**PLANNING COMMISSION STAFF REPORT**  
Meeting Date January 21, 2025

**REPORT TO:** Michael Sable, City Manager  
**REPORT FROM:** Elizabeth Hammond, Planner  
**PRESENTER:** Elizabeth Hammond, Planner  
**AGENDA ITEM:** Conditional Use Permit Resolution for a PUD Amendment, Maplewood Assisted Living, 1744 County Road D East

**Engineering Plan Review****PROJECT:               Maplewood Assisted Living – 1744 County Road D****PROJECT NO:         25-02****COMMENTS BY:      Jon Jarosch, Assistant City Engineer****DATE:                 1-3-2025****PLAN SET:            Engineering plans dated 7-11-2022**

## Environmental Review

# PROPOSED SITE AND UTILITY PLAN MAPLEWOOD ASSISTED LIVING

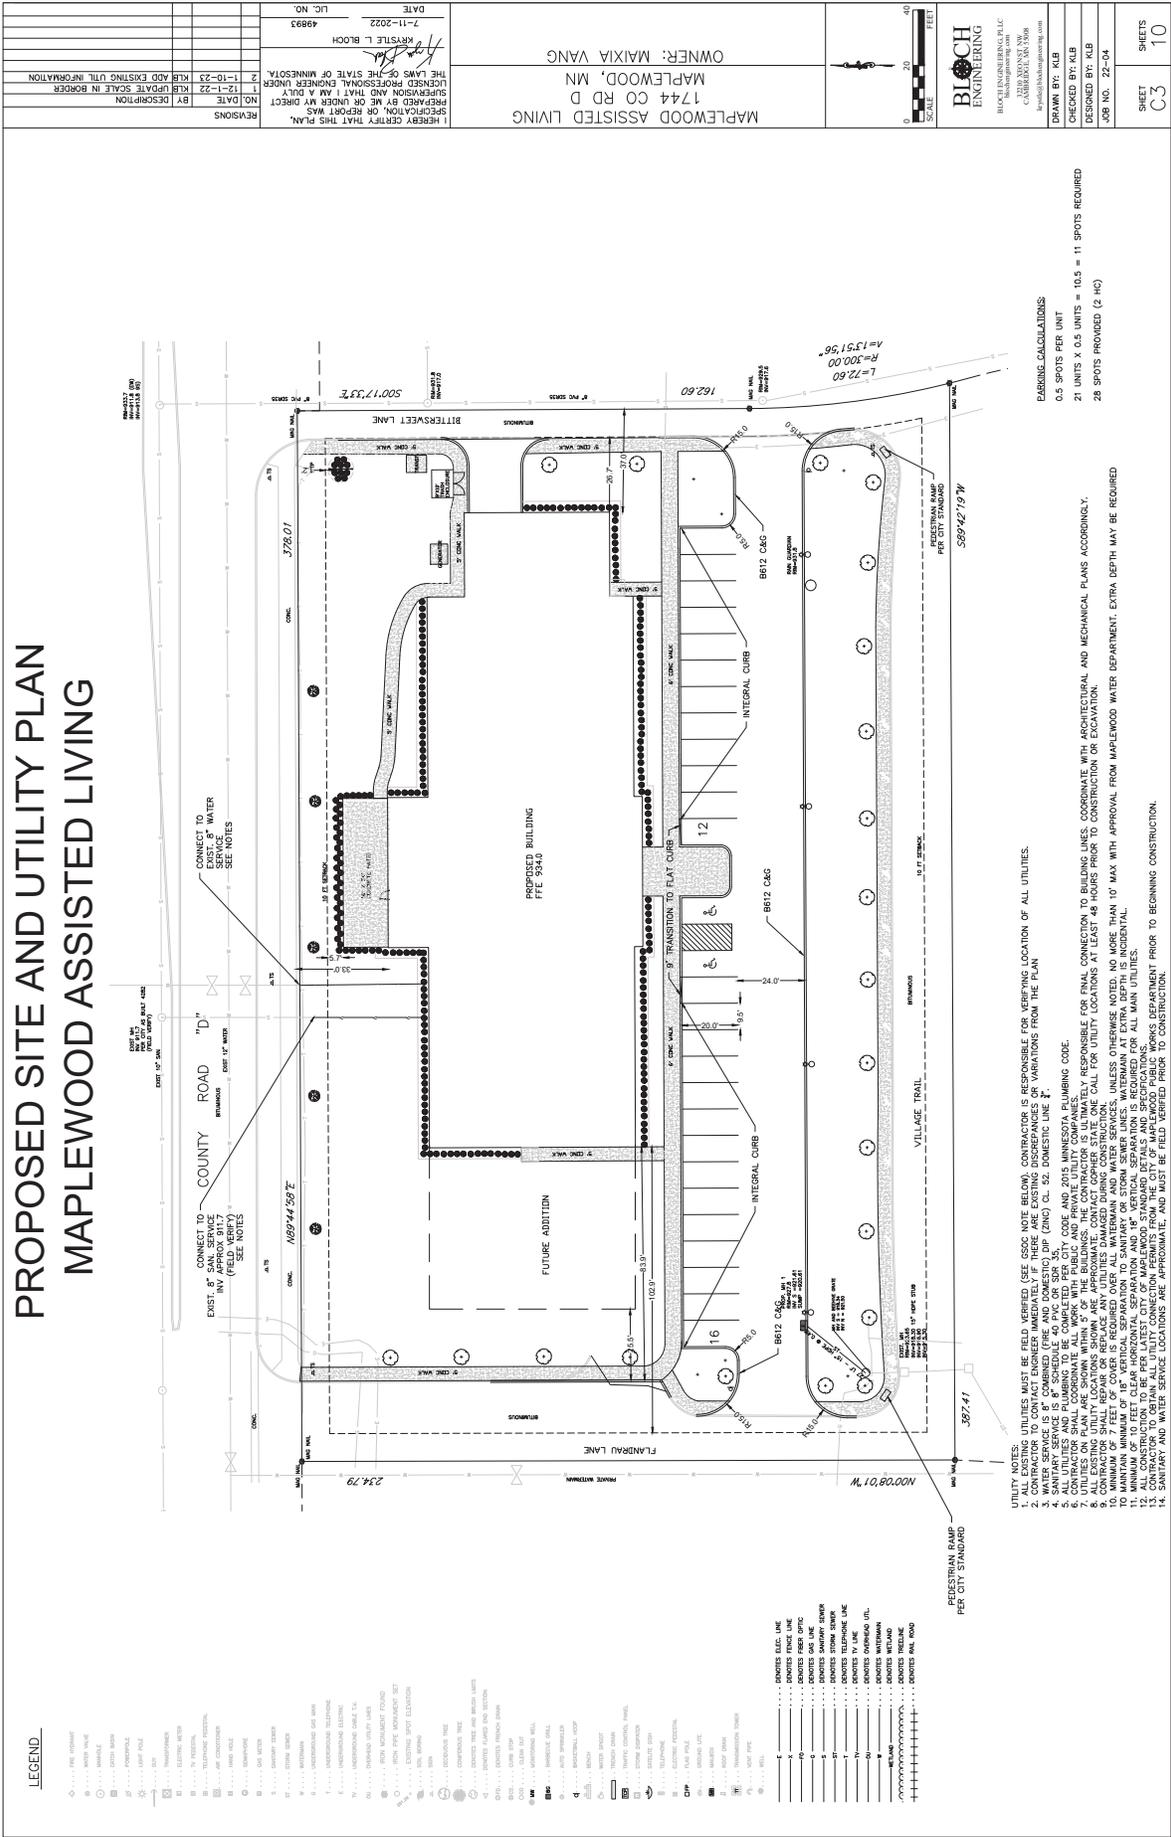
The proposed landscape plan shows a combination of trees, perennial shrubs, and native plants that will complement the site's layout, including 26 trees exceeding the required tree replacement requirement. The plans also show that the trash exterior receptacle and screened roof penetrations match the building's overall color and material scheme, achieving code requirements. The site plan shows a generator and transformer near the screened trash enclosure on the northeast corner of

the building. These are required to be screened. The applicant must submit elevations detailing how each side will be screened before issuing a building permit.

- b. Staff must review and approve elevation perspectives of the transformer and generator, showing that both are adequately screened. The elevations must include all enclosure sides and detail the materials and colors.

# LANDSCAPE AND LIGHTING PLAN MAPLEWOOD ASSISTED LIVING

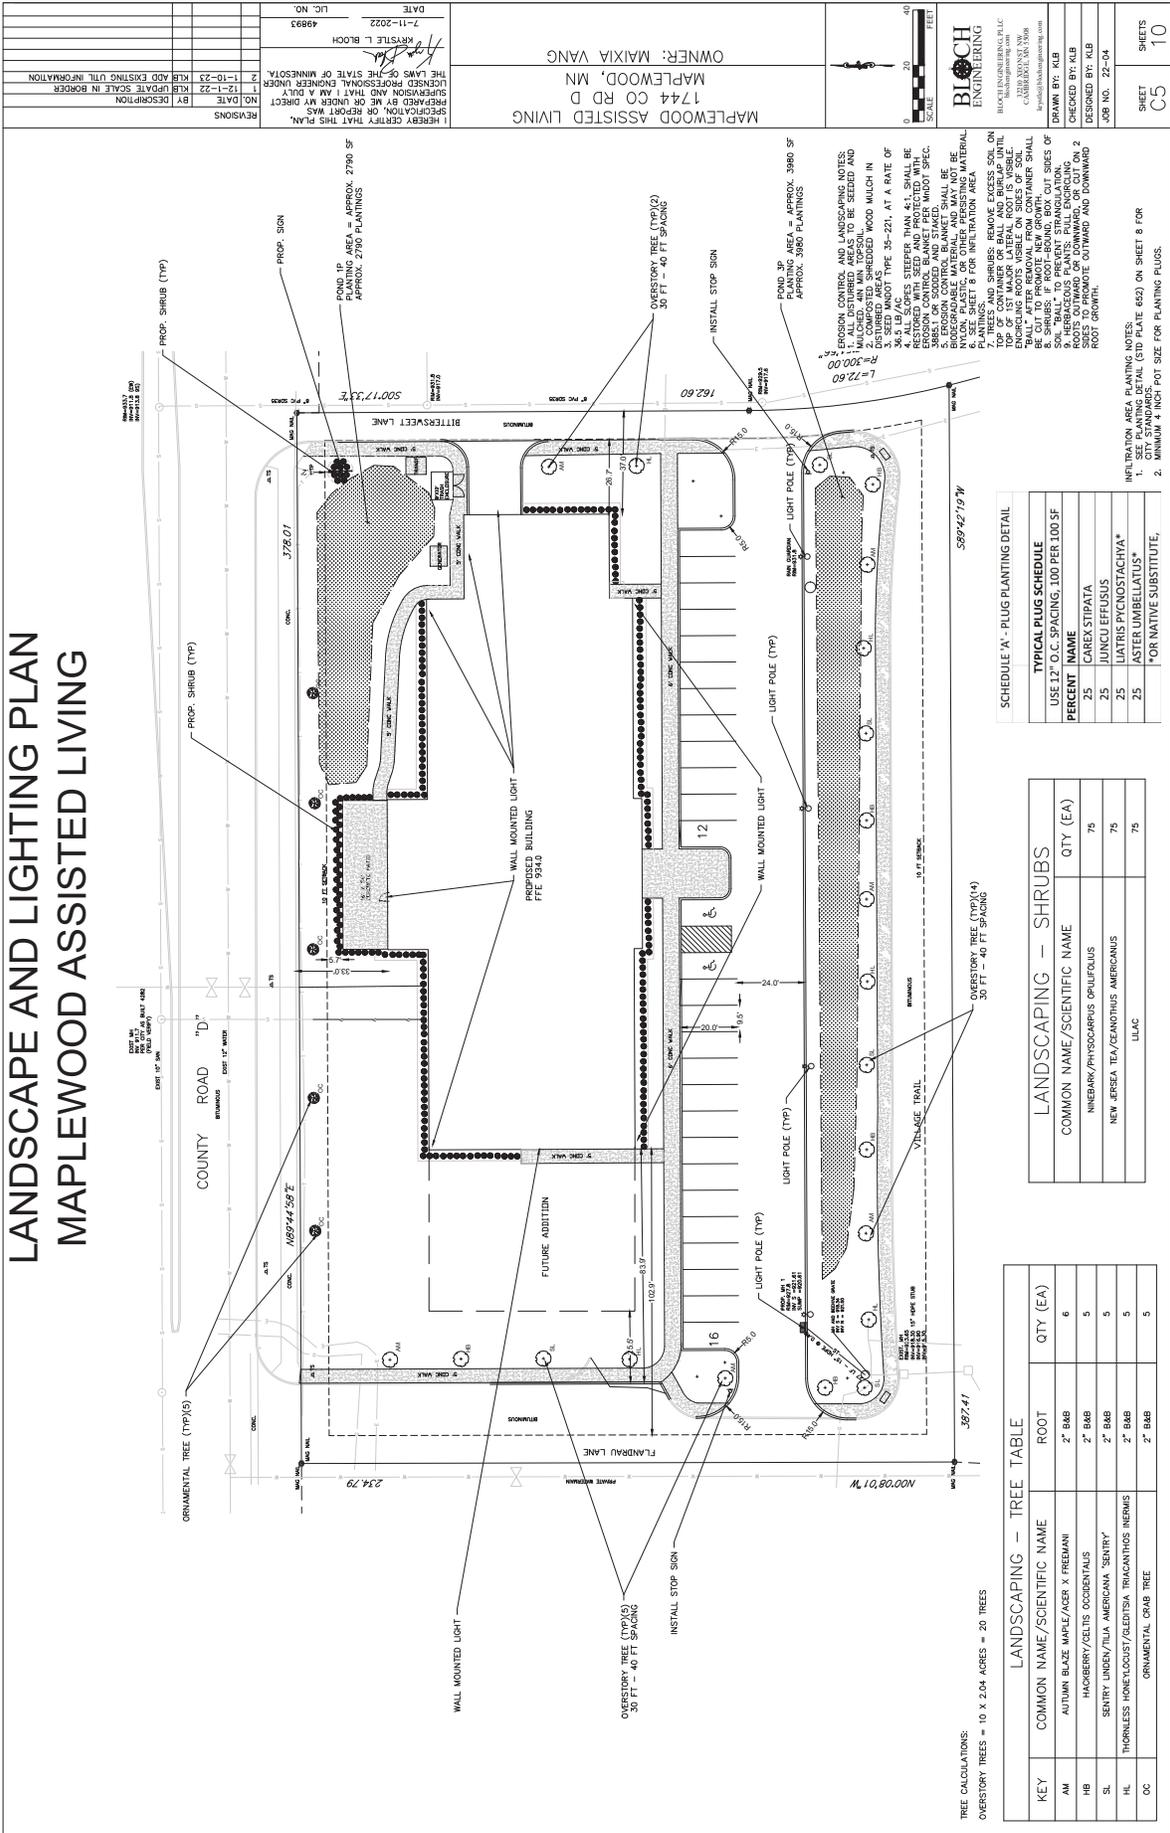
- a) A landscape drawing for each infiltration basin, including list of species, MNDOT seed mix, container size, spacing, and quantities. The plan states "Planting Detail (STD Plate 652) on Sheet 8". No Sheet 8 was included.

- b) The MNDOT seed mix 35-221 is a dry prairie mix and it should work fine in the upper part and slopes of the ponds. The wet areas should include a seed mix such as MNDOT 33-261 for stormwater.

- c) The plan calls for 25 Juncu effusus. The correct spelling is Juncus effuses.
    - d) For any area using a native seed mix (ex: pond slopes), provide a three-year maintenance plan. The plan should include maintenance for each year, including maintenance activities that will be required and what entity (developer, owner, etc.) will take on this responsibility.
